Pymble Station Upgrade

Determination Report

Ref – 6566397

Figure 3 Revised key features of the Proposed Activity (indicative only, subject to detailed design)

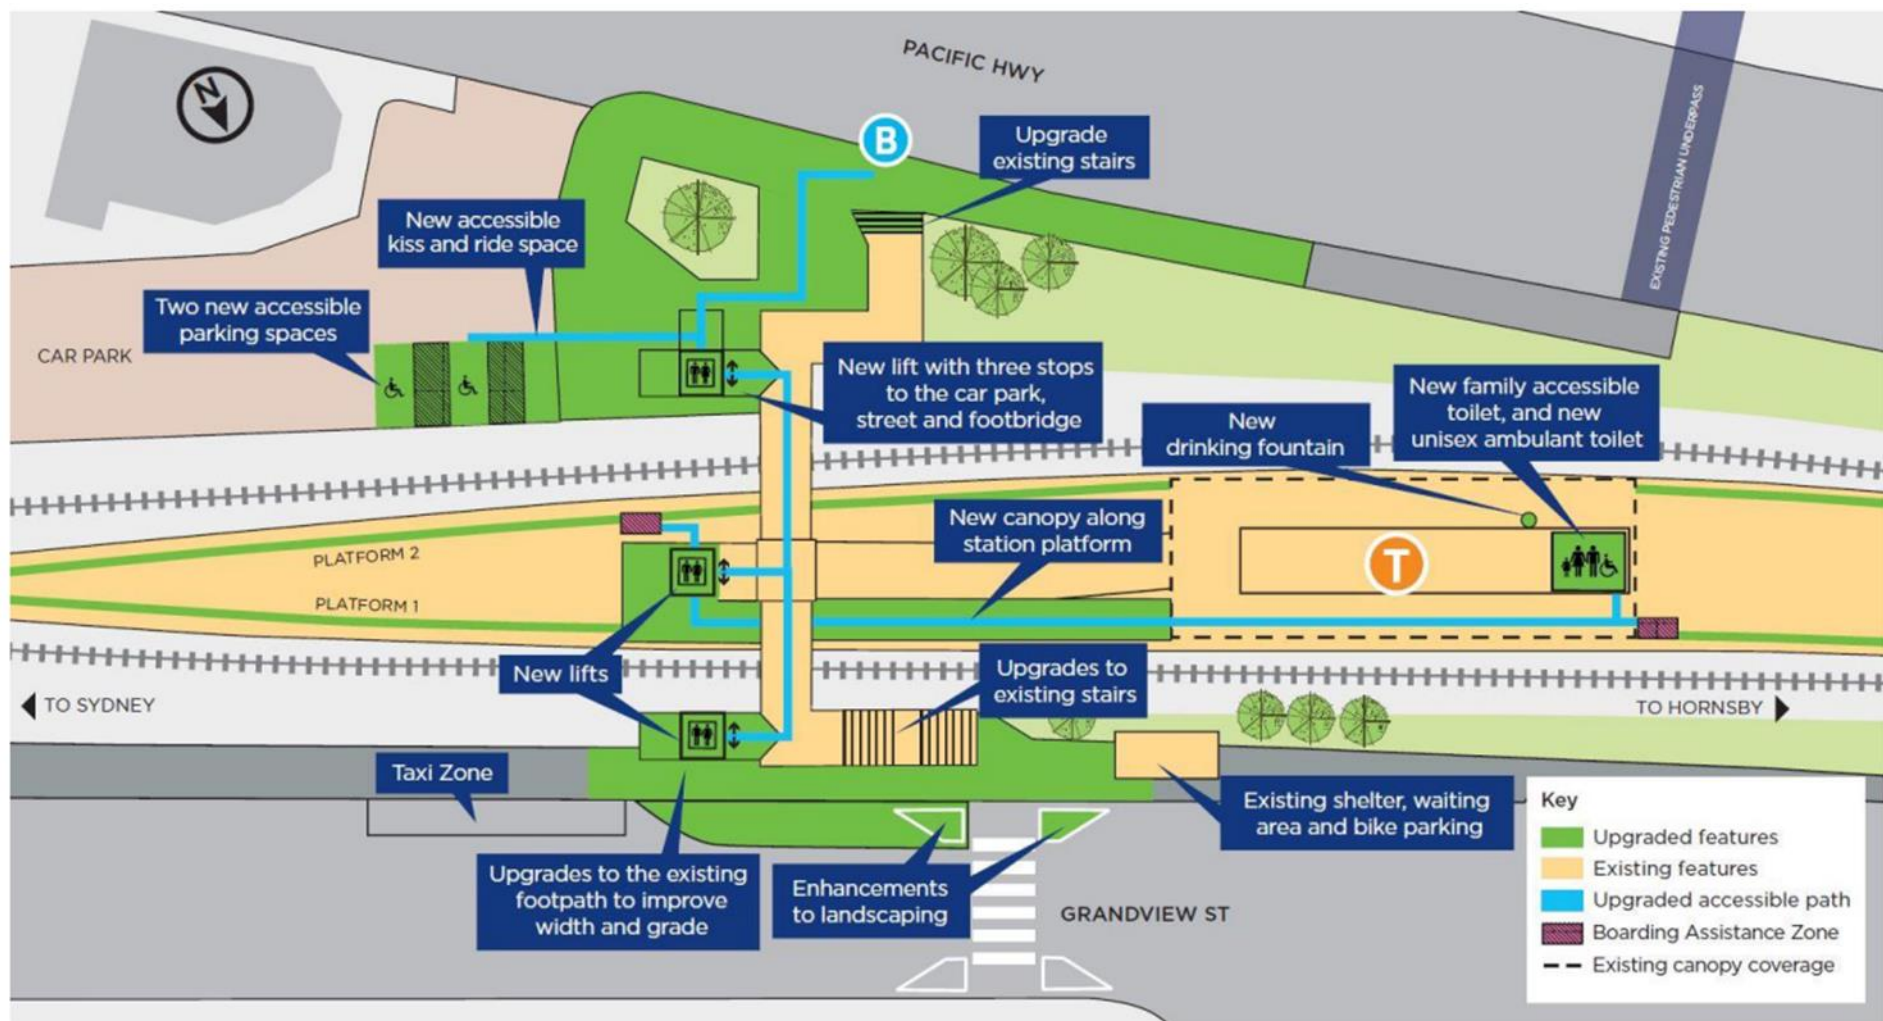
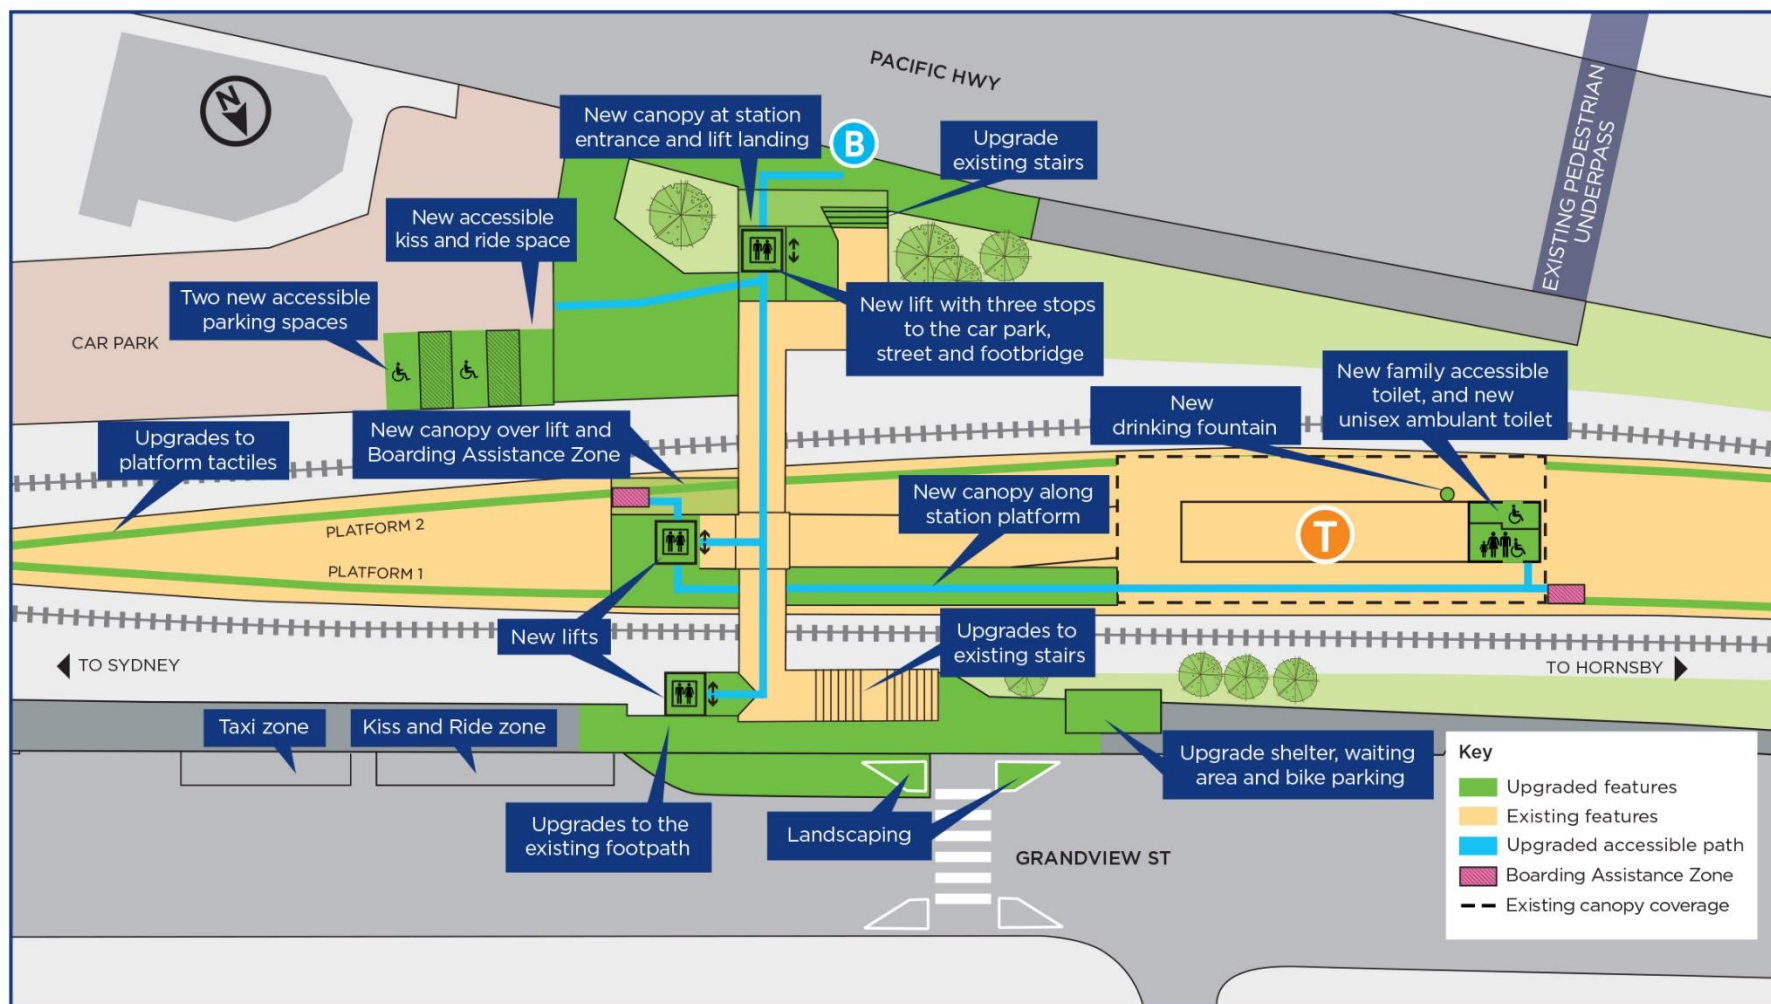
Further design development has resulted in changes to the design of the Proposed Activity since the Pymble Station Upgrade REF was prepared and placed on public display. The Revised key features of the Proposed Activity are shown in Figure 3.

Aspect of the Proposed Activity	Design change	Discussion of impacts
Pacific Highway station entrance	The entry stairs would be fully retained.	<p>The extent of demolition at the station and impact to existing entry stairs would be reduced. As a result, the potential impact on the heritage significance of the station would be reduced. Potential visual impacts would also be reduced.</p> <p>In relation to potential heritage impact, the impact of upgrading the existing stairs and adding an awning at the Pacific Highway entrance would be minor adverse. Existing stair fabric would be retained, with minor alterations required to meet safety requirements While the new awning would add a new built form and an additional visual element to the entrance, this has been mitigated to some degree through the retention of the existing stair.</p> <p>Refer to Appendices C and D for detailed consideration for the visual and heritage impacts of these design changes.</p>

Aspect of the Proposed Activity	Design change	Discussion of impacts
Lift to station footbridge from Pacific Highway	The location of Lift 3 at the Pacific Highway station entrance has been moved to better align with the footbridge.	<p>would have little to no impact on the significance of the station building.</p> <p>The station building is a significant component of Pymble Station. The exterior of the building is of high significance; the interior of the building is of moderate significance. However, the existing male and female toilets have previously been heavily modified.</p> <p>Refer to Appendices C and D for detailed consideration for the visual and heritage impacts of these design changes.</p>
		<p>The proposed new lift location would not introduce additional environmental impacts to what has been assessed in the REF. The altered location means that there would no longer be a lift canopy required at the carpark level, as cover would be provided by the footbridge. The visual impacts of the new lift location are considered to be consistent with those identified in the Landscape Character and Visual Impact Assessment (RPS, 2020c). The heritage impacts of the new lift location are considered to be consistent with those identified in the SOHI (RPS, 220b). Relocating Lift 3 to align with the southern end of the footbridge at Pacific Highway, would visually impact the heritage significant footbridge. Physical impact to significant heritage fabric will remain the same as previously assessed, in that the lift landing structure would be independent from the bridge, minimising the impact to significant fabric.</p> <p>The design change to the location of Lift 3 is required to avoid a high pressure gas main underground at the previous location. The proposed new lift location would also enable easier access for customers entering the station from the Pacific Highway.</p> <p>Refer to Appendices C and D for detailed consideration for the visual</p>

Aspect of the Proposed Activity	Design change	Discussion of impacts
		and heritage impacts of these design changes.
Lifts	The design for the lifts is continuing to be refined, to minimise visual and heritage impacts to the existing character of the station.	<p>The refined lift design would not introduce additional environmental impacts to what has been assessed in the REF.</p> <p>The form, materials and finishes of the lifts have been designed to tie in with existing architectural elements of the station. Changes have also attempted to address community feedback regarding relationship of the new lifts to the historic character of the station through detailing of the lift shafts. Concrete has been chosen for the lift bases as a reference to the form and character of the footbridge rather than the brick character of the platform building. Transport for NSW has successfully implemented this approach at other stations, including Mittagong, through the use of steel detailing and shadow lines in concrete to reference key datum lines in the footbridge and further articulate the lift bases.</p> <p>Refer to Appendices C and D for detailed consideration for the visual and heritage impacts of these design changes.</p>

Grandview Street Shelter	The existing shelters on Grandview Street would be upgraded to improve accessibility.	<p>The upgrade of existing shelters on Grandview Street would have little to no impact on the station, as there would be no direct impact to significant fabric, or areas of archaeological potential, and little to no impact on the setting of the station.</p> <p>The existing road side shelter structure is contemporary and does not contribute to the significance of the station. The shelter would be demolished and replaced with a new lightweight painted steel and glass shelter to provide all weather protection to the new bicycle hoops and an angled bench with DDA compliant armrests and back rest. The structure is intended to reflect the character of the architectural proposal for the station.</p>

Grandview Street overhead wiring	Design development has removed the need for the overhead electrical wiring in Grandview Street to be reinstalled underground.	Removing the need for undergrounding the electrical supply in Grandview Street would mean that the trees would no longer be impacted. Other impacts associated with these works, such as noise, dust, traffic and visual amenity would also be avoided as a result.
